### ADDENDUM NO. 1

To the Drawings and Project Manual dated 16 June 2017

**TAS/ADA FIRE MARSHAL  
DEFERRED MAINTENANCE PROJECTS  
MIDWESTERN STATE  
UNIVERSITY**

Addendum Date: 2 August 2017

FAIN FINE ARTS - SECOND FLOOR - AREA 2A  
PLUMBING PLAN

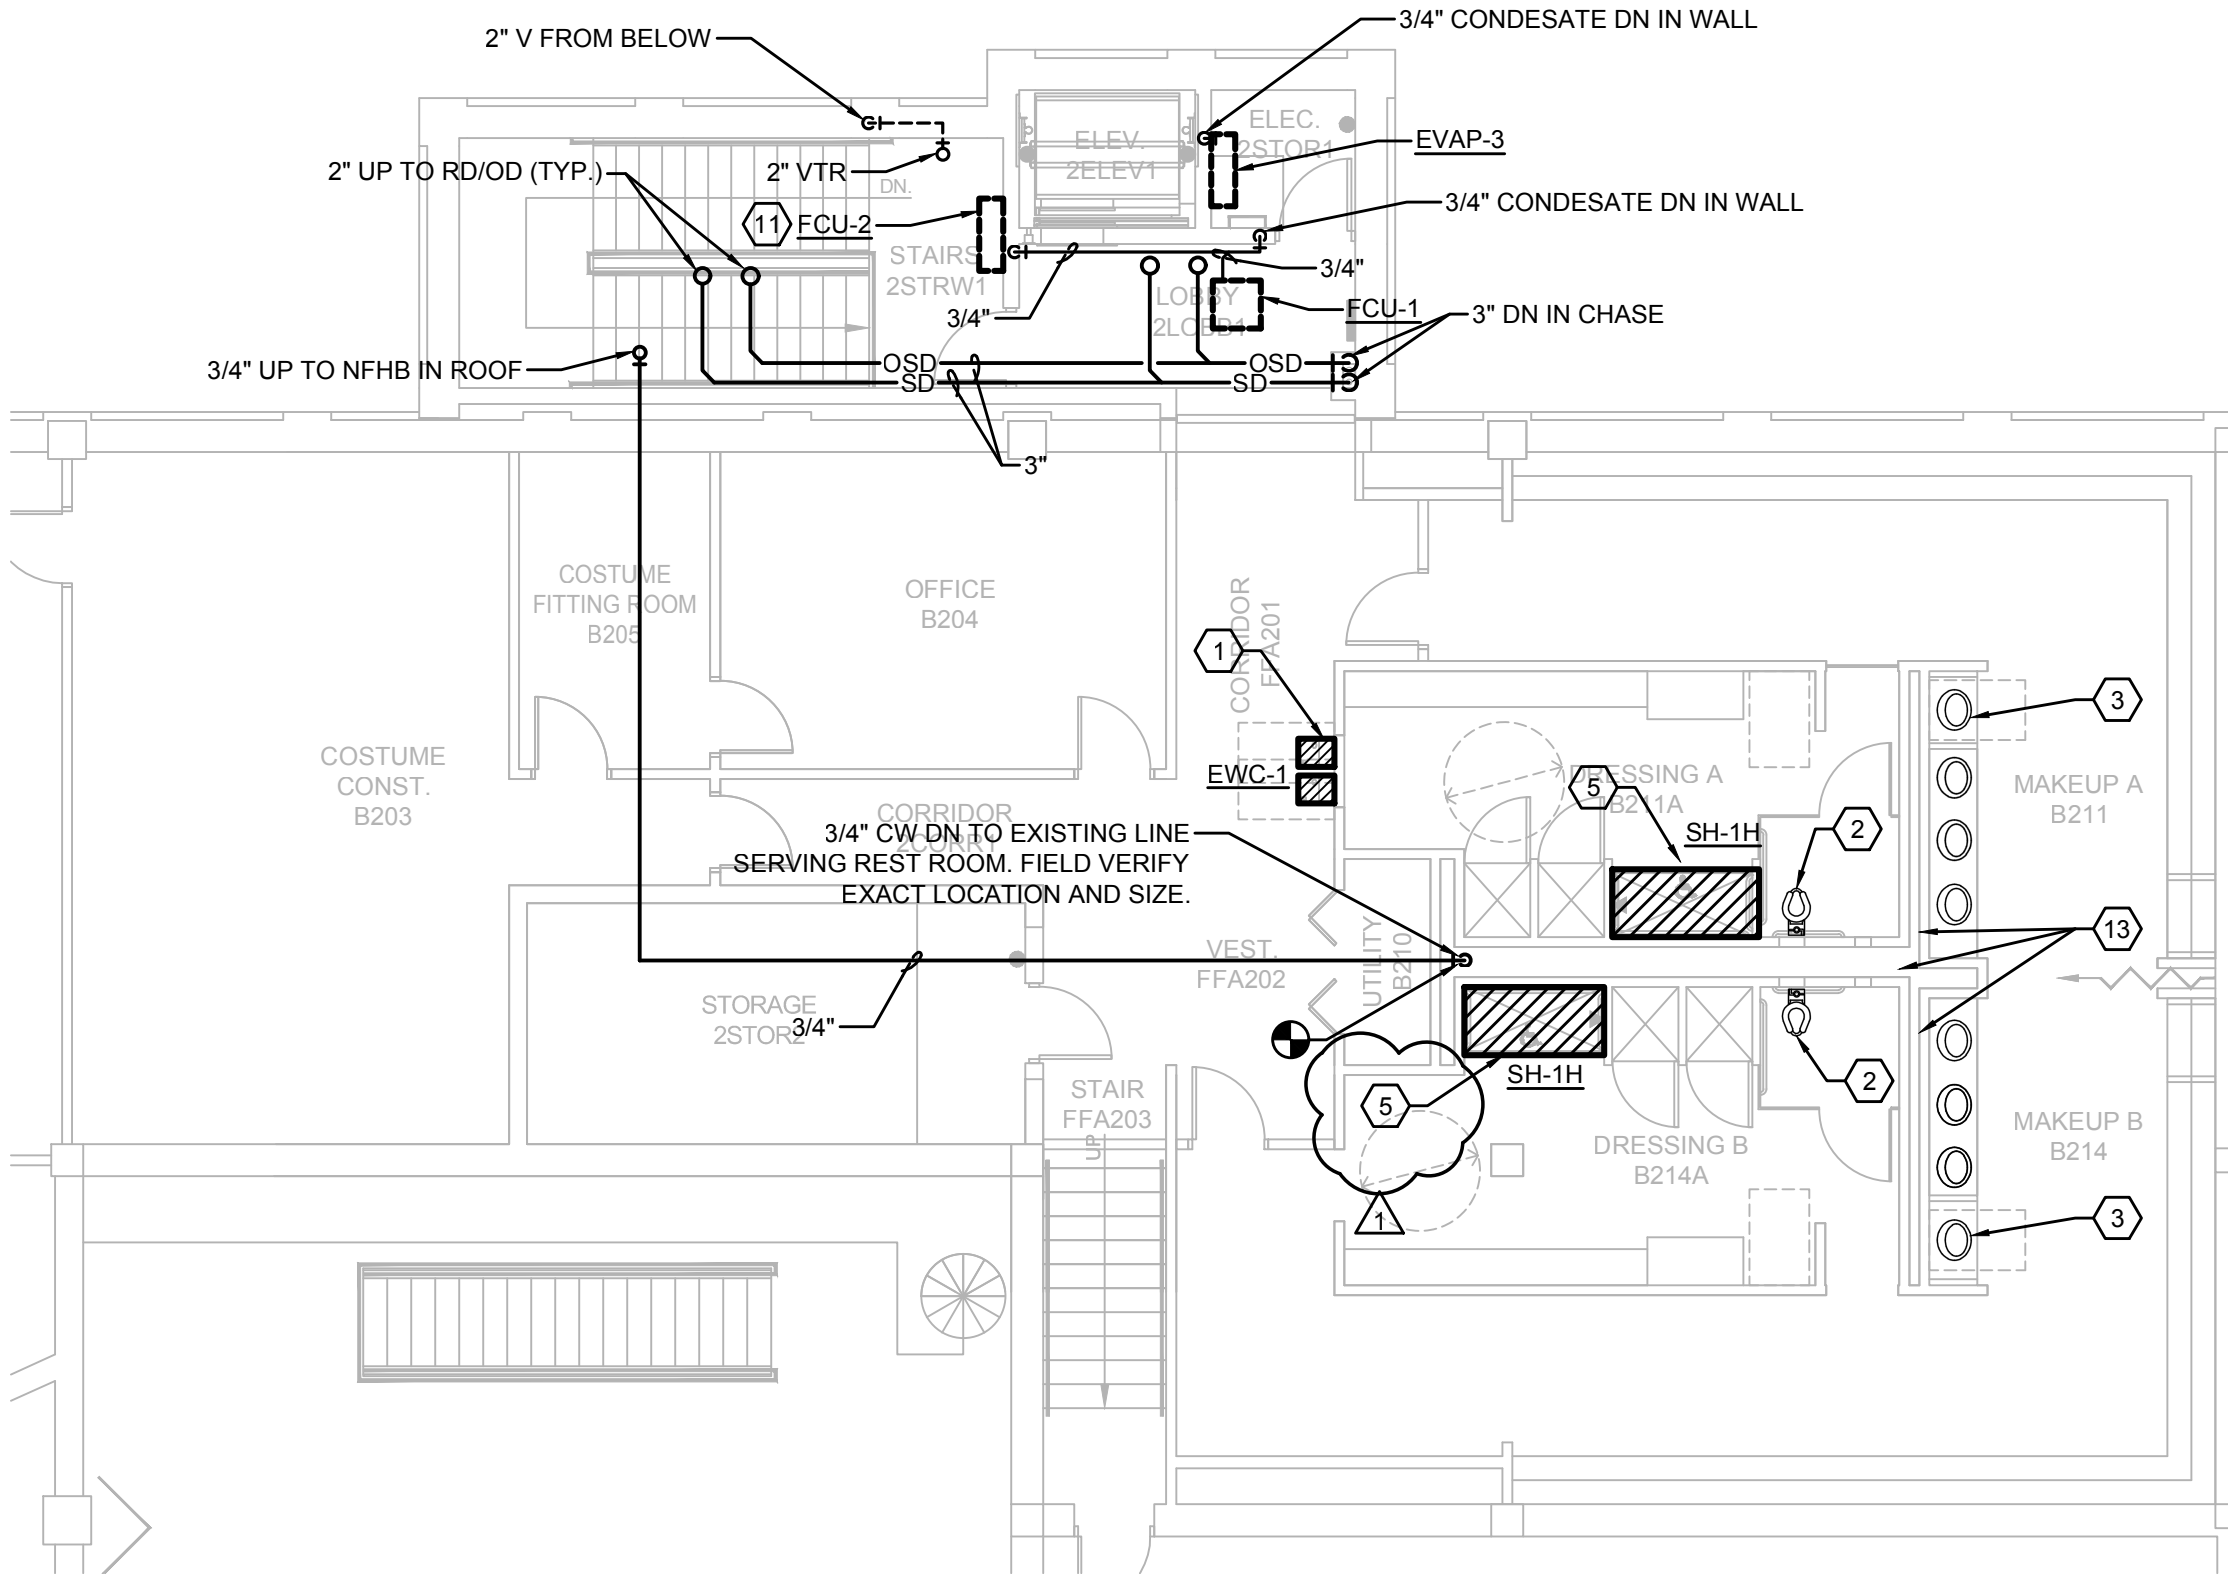
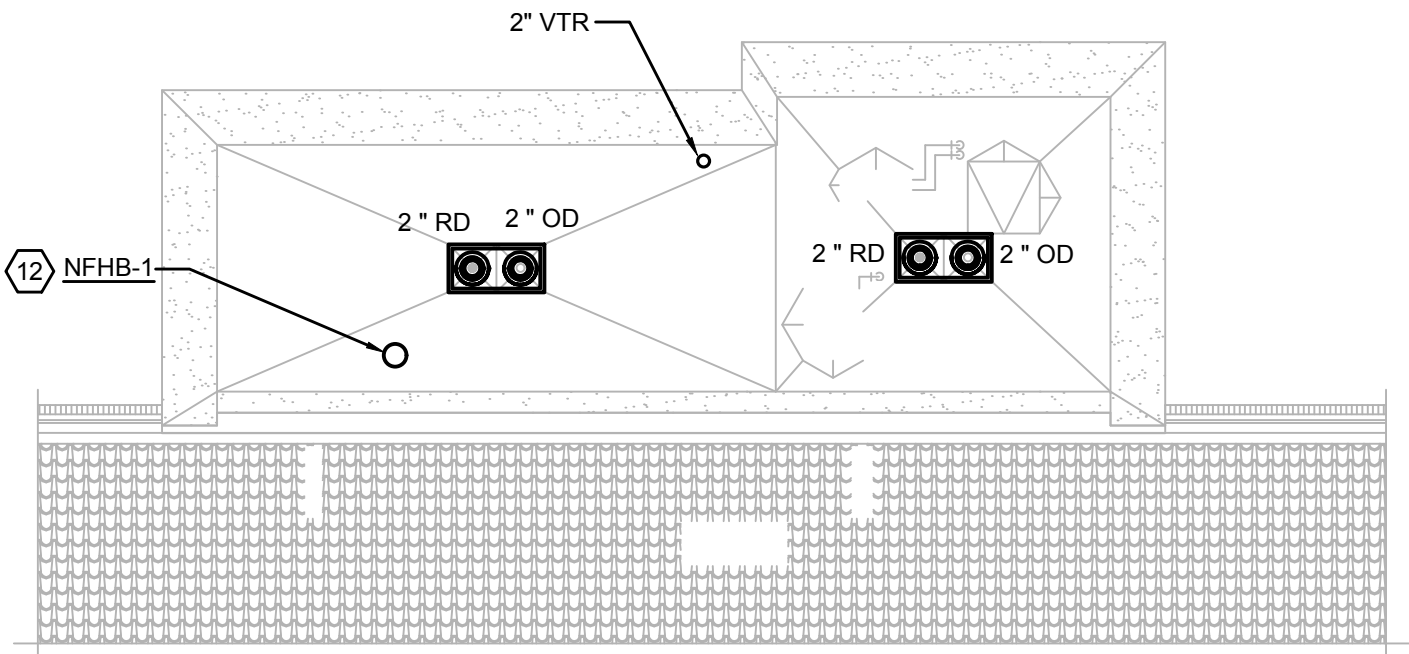
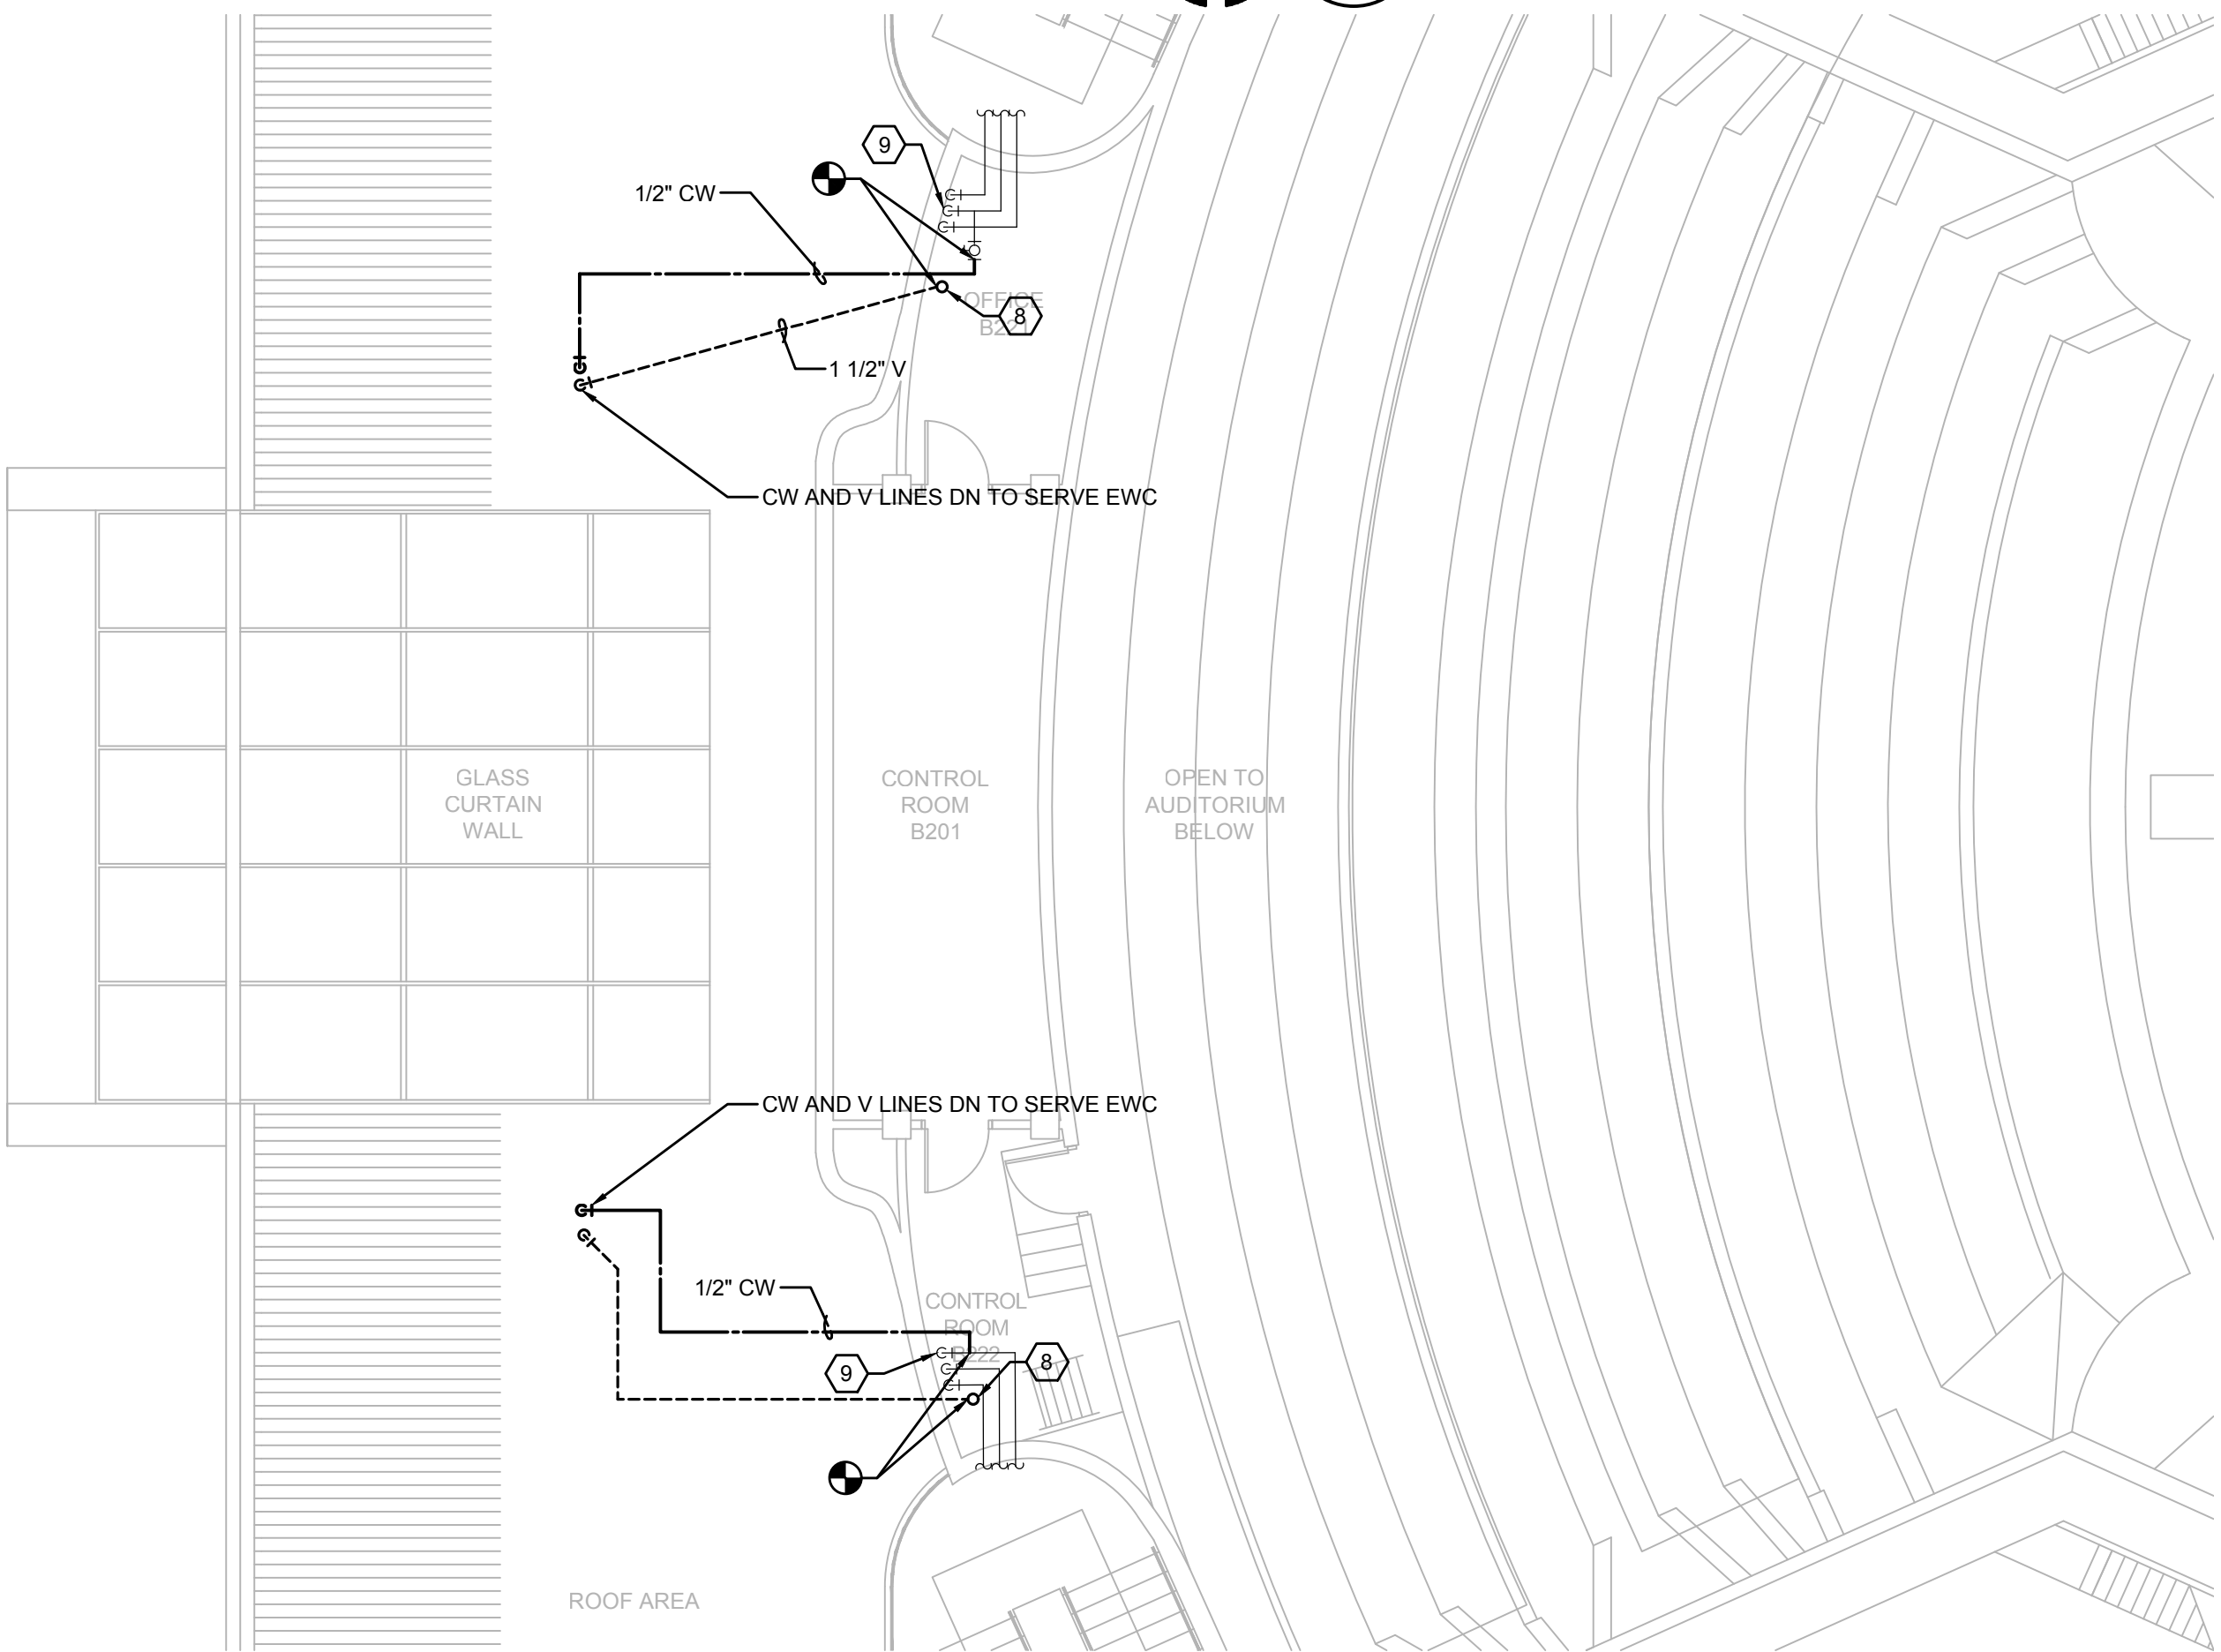
1. Sheet FF-P101 – Revised Drawing as follows:
  - a. Modified Key notes #1, #2 and #3 to clarify the need to provide new plumbing appurtenances to the reinstalled plumbing fixtures.
2. Sheet FF-P102 – Revised Drawing as follows:
  - a. Modified Key notes #1, #2 and #3 to clarify the need to provide new plumbing appurtenances to the reinstalled plumbing fixtures.
